## QUESTIONS AND ANSWERS FOR SAFETY CAMPAIGN (SC057)

### 2003 - 2005 Rio Child Seat Anchorage System

## TECHNICAL SERVICE BULLETIN

**SUBJECT:****SAFETY RECALL CAMPAIGN: 2003-2005 RIO 4-DR CHILD SEAT ANCHORS SYSTEM**

Photo Depicts Rear Seat Removed

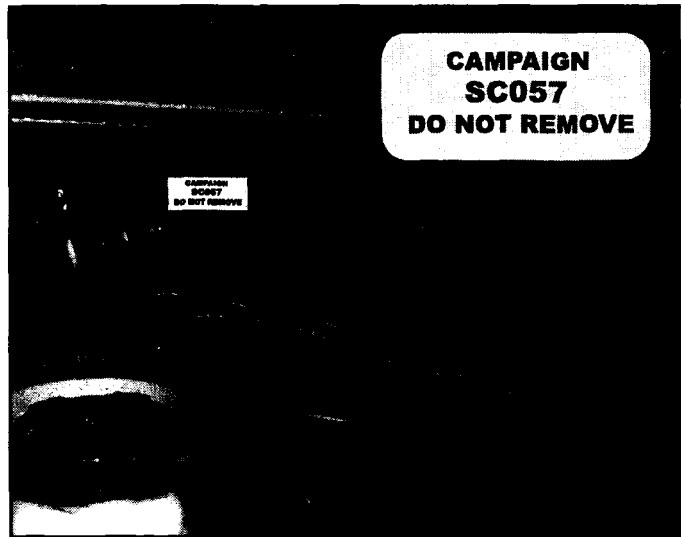
Certain child seat anchors will not fully latch onto the vehicle child lower anchors located between the rear seatback and rear seat cushion because of interference between the child lower anchors and a metal wire located in the frame of the rear seatback.

Follow the procedure in this Campaign to replace the four existing vehicle lower child seat anchors with new improved anchors.

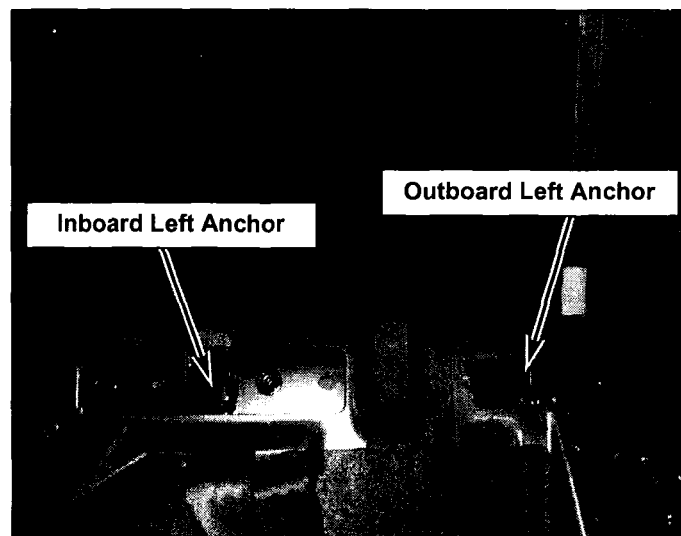
1. Install the two (2) new left lower anchors supplied in the Kit — Child Anchor, P/N-Q8999 9FD000Q.

**Note:** There are two (2) left and two (2) right anchors. The left anchors are stamped “FL” and the right anchors are stamped “FR”. Install the new larger inboard left anchor stamped “FL” using the three(3) bolts from the original anchor and torque to 16-22 lb-ft.
2. Install the new outboard left anchor stamped “FL” using the two (2) bolts from the original anchor and torque to 16-22 lb-ft.
